SUBJECT: Oconee Nuclear Station, Units 1, 2, and 3  
Docket Nos. 50-269, 50-270, and 50-287

McGuire Nuclear Station, Units 1 and 2  
Docket Nos. 50-369 and 50-370

Catawba Nuclear Station, Units 1 and 2  
Docket Nos. 50-413 and 50-414

Application for Technical Specification Change to  
Add/Revise LCO 3.0.8 on the Inoperability of Snubbers  
Using the Consolidated Line Item Improvement Process  
(CLIIP)

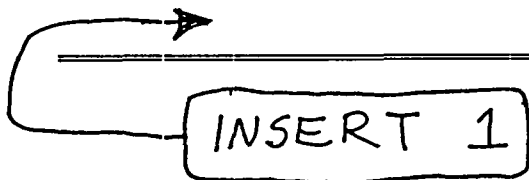
LCO 3.0.1 LCOs shall be met during the MODES or other specified conditions in the Applicability, except as provided in LCO 3.0.2 ~~and LCO 3.0.7~~ and LCO 3.0.8

**INSERT 1**

**LCO 3.0.8** When one or more required snubbers are unable to perform their associated support function(s), any affected supported LCO(s) are not required to be declared not met solely for this reason if risk is assessed and managed, and:

- a. the snubbers not able to perform their associated support function(s) are associated with only one train or subsystem of a multiple train or subsystem supported system or are associated with a single train or subsystem supported system and are able to perform their associated support function within 72 hours; or
- b. the snubbers not able to perform their associated support function(s) are associated with more than one train or subsystem of a multiple train or subsystem supported system and are able to perform their associated support function within 12 hours.

At the end of the specified period the required snubbers must be able to perform their associated support function(s), or the affected supported system LCO(s) shall be declared not met.

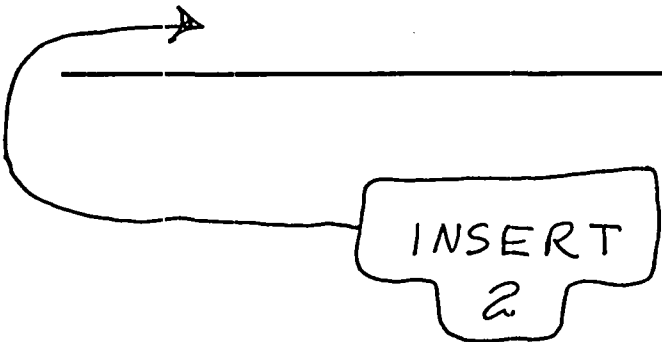
## INSERT 2

LCO 3.0.8 establishes conditions under which systems are considered to remain capable of performing their intended safety function when associated snubbers are not capable of providing their associated support function(s). This LCO states that the supported system is not considered to be inoperable solely due to one or more required snubbers not capable of performing their associated support function(s). This is appropriate because a limited length of time is allowed for maintenance, testing, or repair of one or more required snubbers not capable of performing their associated support function(s) and appropriate compensatory measures are specified in the snubber requirements, which are located outside of the Technical Specifications (TS) under licensee control. The snubber requirements do not meet the criteria in 10 CFR 50.36(c)(2)(ii), and, as such, are appropriate for control by the licensee.

If the allowed time expires and the required snubber(s) are unable to perform their associated support function(s), the affected supported system's LCO(s) must be declared not met and the Conditions and Required Actions entered in accordance with LCO 3.0.2.

LCO 3.0.8.a applies when one or more required snubbers are not capable of providing their associated support function(s) to a single train or subsystem of a multiple train or subsystem supported system or to a single train or subsystem supported system. LCO 3.0.8.a allows 72 hours to restore the required snubber(s) before declaring the supported system inoperable. The 72 hour Completion Time is reasonable based on the low probability of a seismic event concurrent with an event that would require operation of the supported system occurring while the required snubber(s) are not capable of performing their associated support function and due to the availability of the redundant train of the supported system.

LCO 3.0.8.b applies when one or more required snubbers are not capable of providing their associated support function(s) to more than one train or subsystem of a multiple train or subsystem supported system. LCO 3.0.8.b allows 12 hours to restore the required snubber(s) before declaring the supported system inoperable. The 12 hour Completion Time is reasonable based on the low probability of a seismic event concurrent with an event that would require operation of the supported system occurring while the required snubber(s) are not capable of performing their associated support function.

LCO 3.0.8 requires that risk be assessed and managed. Industry and NRC guidance on the implementation of 10 CFR 50.65(a)(4) (the Maintenance Rule) does not address seismic risk. However, use of LCO 3.0.8 should be considered with respect to other plant maintenance activities, and integrated into the existing Maintenance Rule process to the extent possible so that maintenance on any unaffected train or subsystem is properly controlled, and emergent issues are properly addressed. The risk assessment need not be quantified, but may be a qualitative awareness of the vulnerability of systems and components when one or more required snubbers are not able to perform their associated support function.
